City of El Paso – City Plan Commission Staff Report

Case No: SUSU13-00033 Tierra Del Este Unit Seventy Two
Application Type: Major Preliminary
CPC Hearing Date: June 27, 2013
Staff Planner: Nathaniel Baker, (915) 541-4192, bakernt@elpasotexas.gov
Location: East of John Hayes Street and north of Pebble Hills Blvd.
Acreage: 97.6 acres
Rep District: 5
Existing Use: Undeveloped
Existing Zoning: R-5 (Residential)
Proposed Zoning: R-5 (Residential)
Nearest Park: Park in block 430
Nearest School: El Dorado Ninth Grade High (0.5 miles)
Park Fees Required: N/A
Impact Fee Area: N/A
Property Owner: Ranchos Real XVI, LLC.
Applicant: Conde Inc.
Representative: Conde Inc.

ATTACHMENT 3

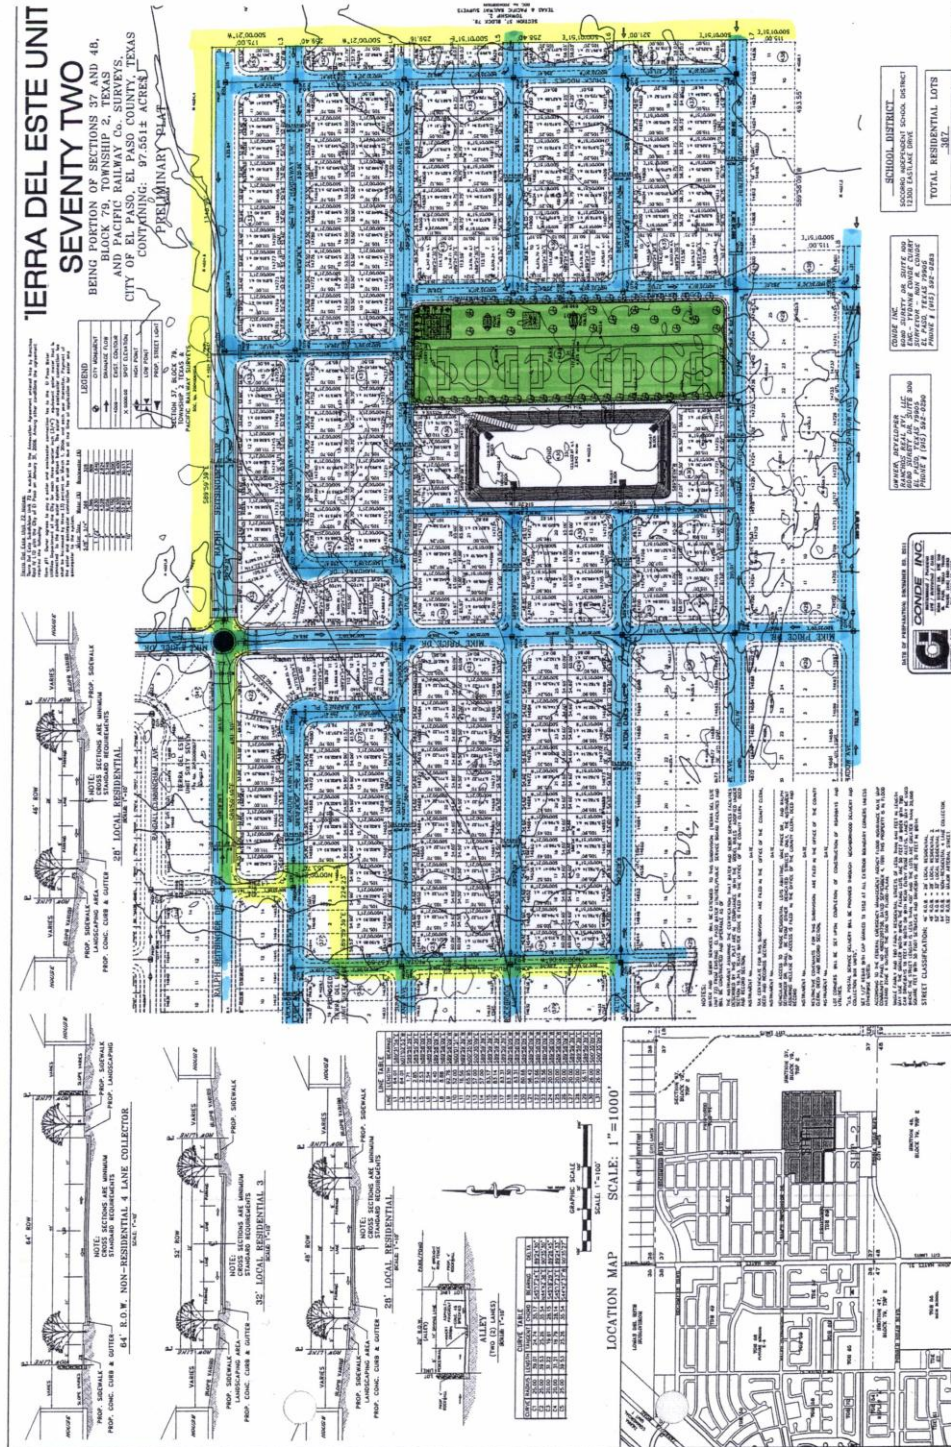
- All local street cross-sections shall include a 5-foot landscaped parkway per the Design Standards for Construction

17. Provide street trees within a 7'-9' wide parkway as required per ordinance #017528; provide scattered trees as shown on the preliminary plat along the flat perimeter areas on the rim of the park / pond and next to the pond's rock wall.

18. Parks requests for the park area where the soccer fields are to be located to be laser leveled.
19. Park improvements shall include an age appropriate (5-12 years) playground structure, a double swing bay, and accessible picnic tables & benches on concrete pads, and sand box as shown on the preliminary plat.

Add Eastside Service Area Impact Fee Table and keep Annexation table.
